# Cotton Clothes (BD) Ltd.

Kazi Tower, 27 Road, Gazipura, Tongi, Gazipur  
(23.920254, 90.388785)

8<sup>th</sup> March 2015

# Observations

**Column in toilet area  
appears overstressed**

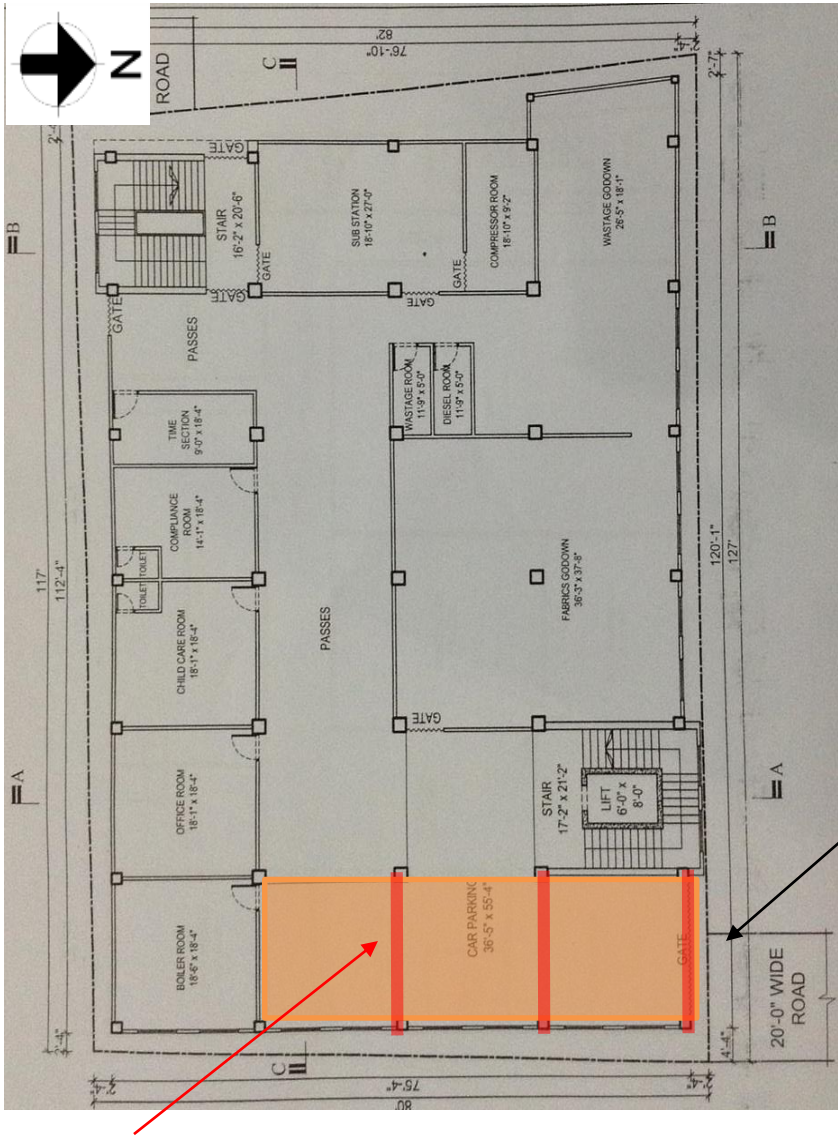
Initial calculations indicate that the highlighted column appears to be highly stressed due to façade cantilever and heavy toilet build-up (floor, walls, overhead slab).

Item No.	Observation	Recommended Action Plan	Recommended Timeline
1	Toilet column appears overstressed	Building engineer to review design, loads and column stresses in area identified above.	6-weeks
2	Toilet column appears overstressed	Verify in-situ concrete strength either by taking 100mm dia. cores from 4 columns at Ground Floor or by using existing cylinder strength data for the ground floor columns if available.	6-weeks
3	Toilet column appears overstressed	Produce and actively manage a loading plan for all floor plates within the factory giving consideration to floor capacity and column capacity.	6-months
4	Toilet column appears overstressed	Any remedial measures recommended by building engineer to be implemented.	6-months
5	Mid-span crack in slab above loading bay (missing beams)	Building engineer to review design, loads and slab stresses in area identified above.	6-weeks
6	Mid-span crack in slab above loading bay (missing beams)	Avoid increasing live loads in the rooms immediately above the affected slabs pending engineering review (i.e. do not use for storage)	6-weeks

# Mid-span crack in slab above loading bay (missing beams)

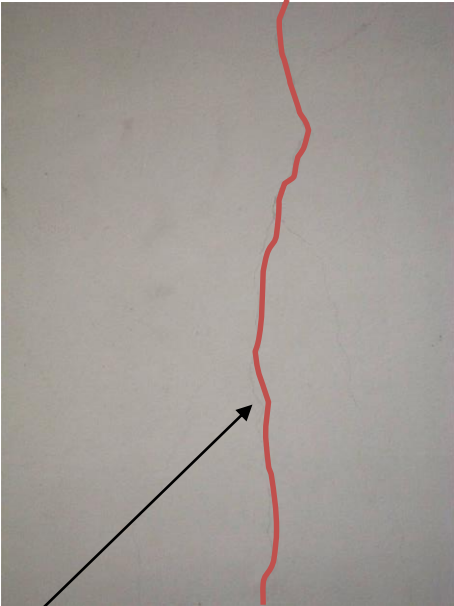
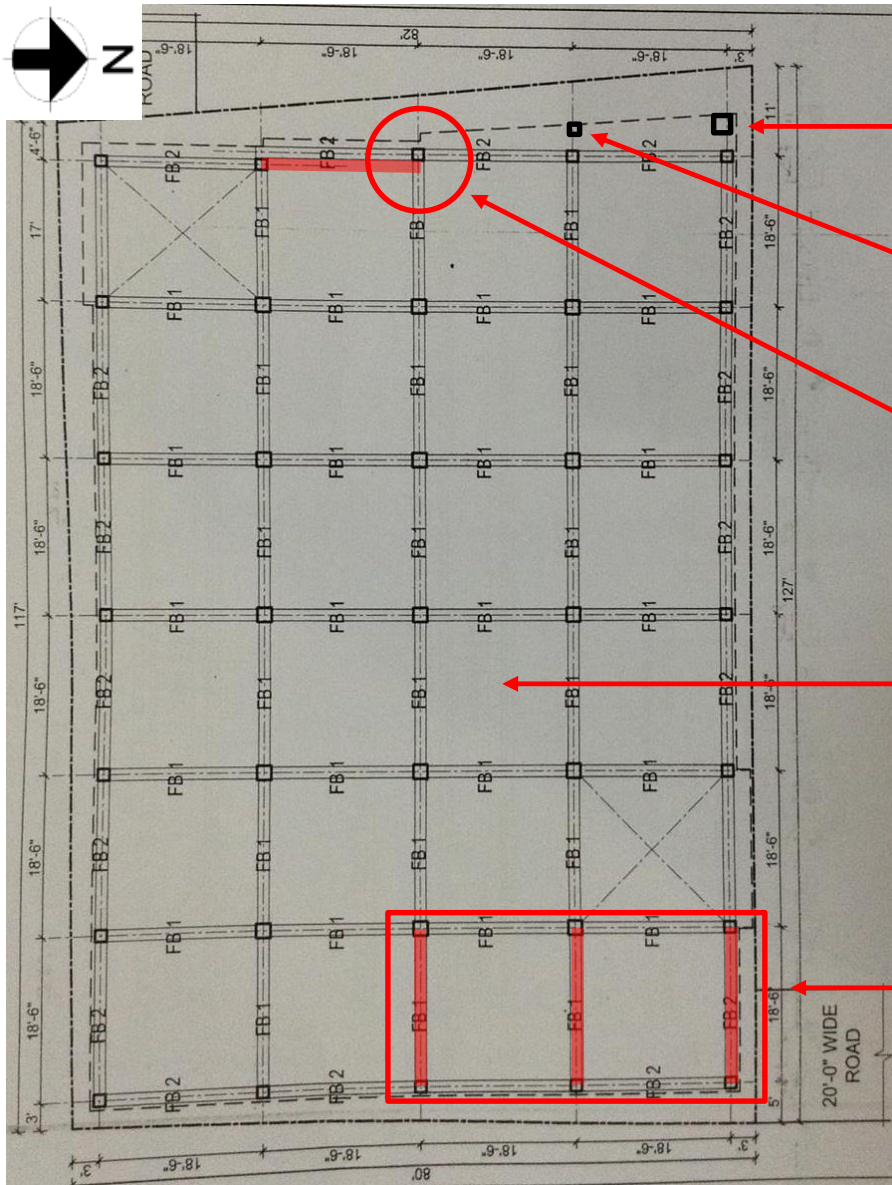
Crack in mid-span of slab; appears to be due to deflection/bending in slab

Missing beam in 1<sup>st</sup> floor slab.

7	Mid-span crack in slab above loading bay (missing beams)	Produce and actively manage a loading plan for all floor plates within the factory giving consideration to floor capacity and column capacity.	6-months
8	Mid-span crack in slab above loading bay (missing beams)	Any remedial measures recommended by building engineer to be implemented.	6-months

# Cracking in Slabs and Beams

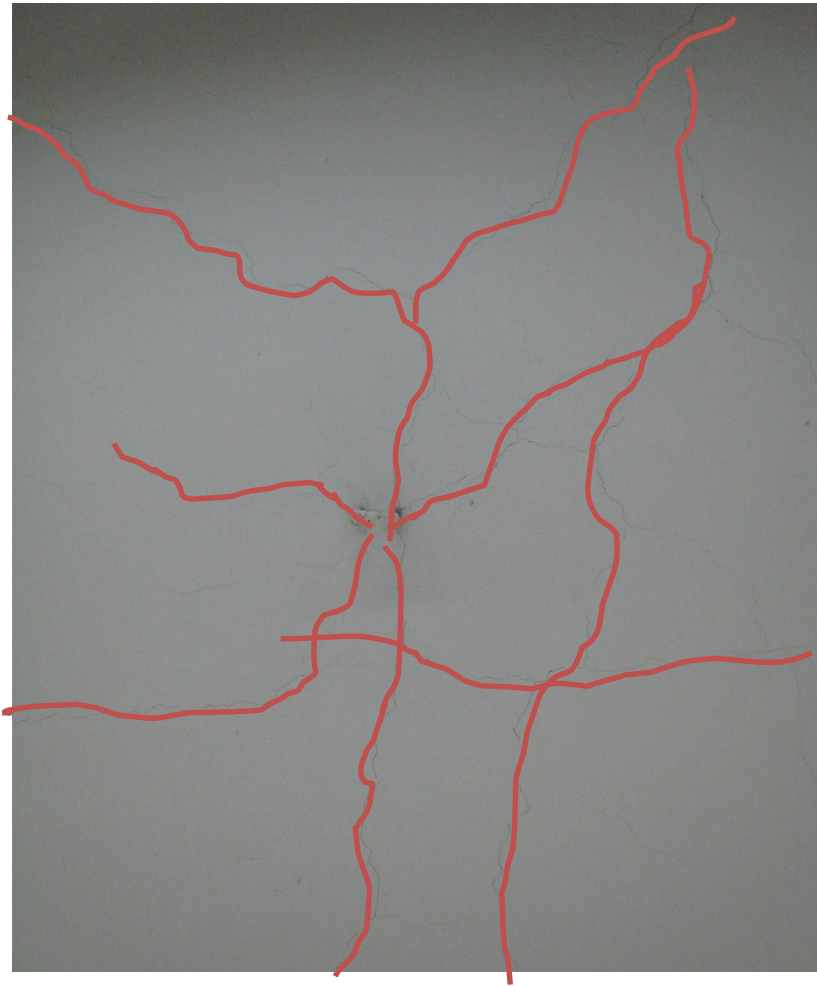
Cracks in slabs and beams on all floors but most prevalent on 3<sup>rd</sup>, 4<sup>th</sup> and 5<sup>th</sup> floor (roof). Appears to be due to deflection/bending - example illustrated with crack patterns on 5<sup>th</sup> floor.

Item No.	Observation	Recommended Action Plan	Recommended Timeline
9	Discrepancies between drawings and on-site observations	Update as-built drawings.	6-months
10	Cracking in slabs and beams	Verify slab thickness in the middle of at least one bay at each level, e.g. by drilling a small hole through slab.	6-months
11	Cracking in slabs and beams	Building engineer to review design, loads and slab stresses.	6-months
12	Cracking in slabs and beams	Conduct regular inspection of cracks.	6-months
13	Settlement induced cracks in brickwork façade	Conduct regular inspection of cracks.	6-months
14	Settlement induced cracks in brickwork façade	If cracks grow larger engage an engineer to investigate cause and determine if structural remedial works are necessary.	6-months
15	Lightweight roofs with non-engineered connections	Building engineer to check the structures with particular reference to wind uplift and connection / anchorage details and make recommendations.	6-months

**Cracks in masonry facade,  
possibly settlement induced**

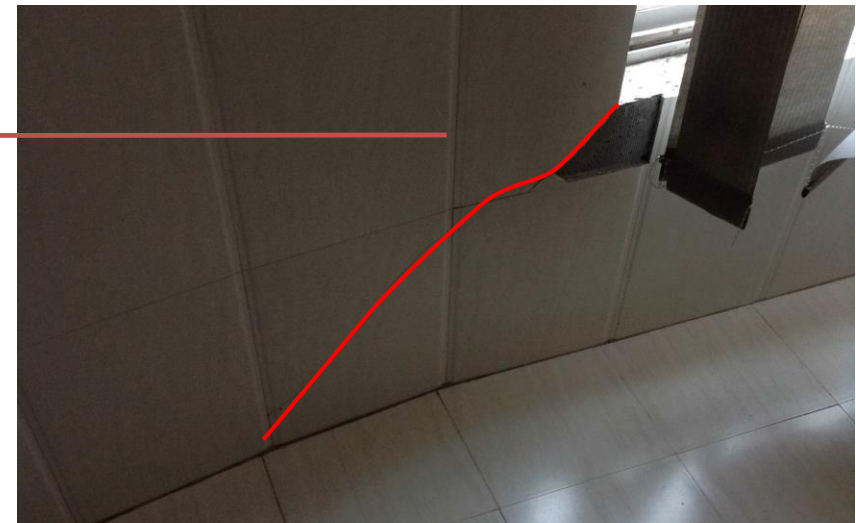
Cracks in façade brick work at North Elevation possibly due to settlement of perimeter column (similar orientation of cracks on several panels)

# Lightweight roofs with non-engineered connections

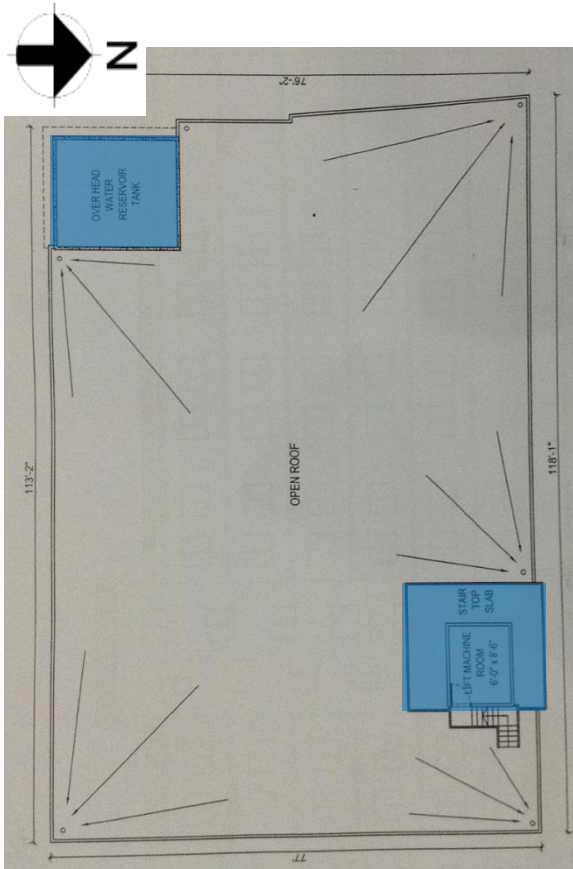
Lightweight roofs appear susceptible to wind uplift, particularly edge overhangs. Some of the details appear non-engineered.

16	Lightweight roofs with non-engineered connections	Implement recommendations of building engineer.	6-months
17	Restraint to brickwork façade at south west core	Building engineer to check restraint to brickwork façade and make recommendations.	6-months
18	Restraint to brickwork façade at south west core	Implement recommendations of building engineer.	6-months

# Restraint to brickwork façade at south west core

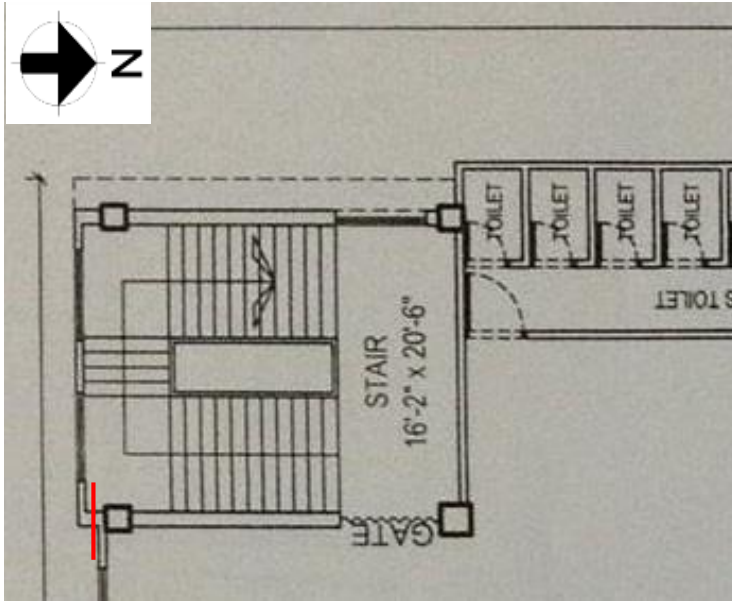
Façade brickwork at south west stair core appears unrestrained to RC column. Risk of falling brickwork in strong winds / if problem worsens.
